Re: San Jacinto River Waste Pits Superfund Site; Notification of Serious Deficiency Pursuant to Paragraph 59 of Administrative Settlement Agreement and Order on Consent for Remedial Design, CERCLA Docket No. 06-02-18

**EPA Response to Respondents' January 25, 2024, Plan and Supplemental EPA  
Comments on the 90% Remedial Design ("EPA Response and Supplemental EPA  
Comments")**

Figure – Excerpt from Hydraulic Heave Report (Piezometric Data at SJMW016)

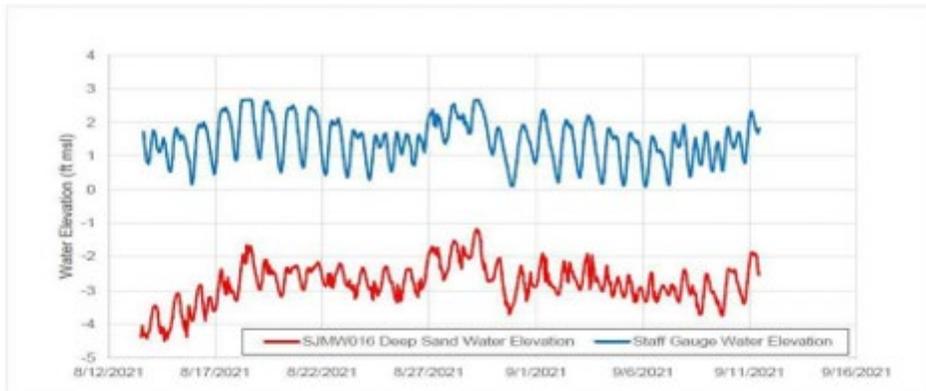
3. The assumption that the water level in sand lenses to be the same as that assumed at the top of the Beaumont Sand layer needs justification. Are the sand layers also under artesian pressure? What thickness of these layers should be considered to be a concern for bottom heave at the excavation subgrade?

Figure – Excerpt from Hydraulic Heave Report (Sediment Unit Weight)

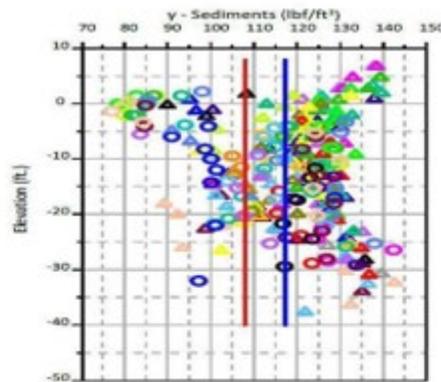
6. The report should provide details on how the design unit weight was selected in comparison with the mean value.
7. A majority of the cases analyzed meet the desired factor of safety (FS) values. The cases showing less than desired FS value have used a higher piezometric water level in analysis. Additionally, some of the cases can be considered to be OK by observation when we have total FS of 1.18 and effective FS of 1.53 (or total of 1.24 and effective of 1.71).
